<b>HYUNDAI</b> <b>Technical Service Bulletin</b>	GROUP <b>BODY ELECTRICAL</b>	NUMBER <b>24-BE-007H-1</b>
	DATE <b>NOVEMBER 2024</b>	MODEL(S) <b>SEE BELOW</b>
<b>SUBJECT:</b> COAXIAL CABLE SHIELD ADJUSTMENT FOR DISPLAY SCREEN FLICKERING/BLANK

**This TSB supersedes 24-BE-007H to include Santa Cruz (NXT), Santa Fe Hybrid (MX5A HEV), and Tucson (NX4A) models, add additional Op Codes to the Warranty Information table on page 2, and include shop manual details for the added models on pages 3-4.**

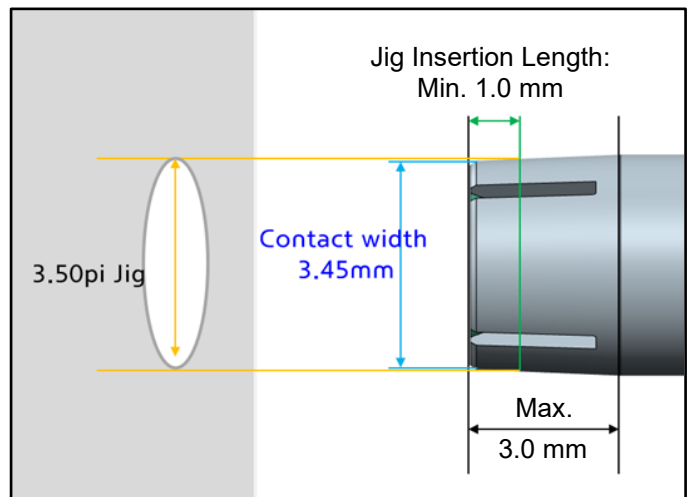
Shown at right is a coaxial cable shield (K) that is too wide and needs adjustment.

Notice that the coaxial cable shield is larger than the hole of the jig (L). Proceed to next step.

5. Begin the shield adjustment by inserting the end of the coaxial cable at an angle as shown.

Gently rotate the jig to allow the entire shield to enter the opening.

6. Then insert the shield all the way inside the jig.

Insert the coaxial cable shield at a **minimum** depth of **1 mm** up to a **maximum** depth of **3 mm**.

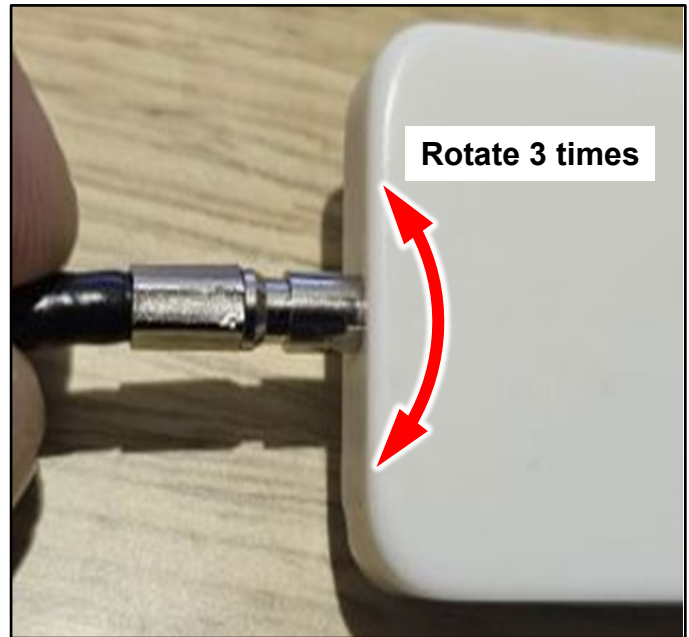
7. Once inserted, rotate the jig around the shield 3 times.

This will reduce the width of the shield to enable a better connection in the connector.
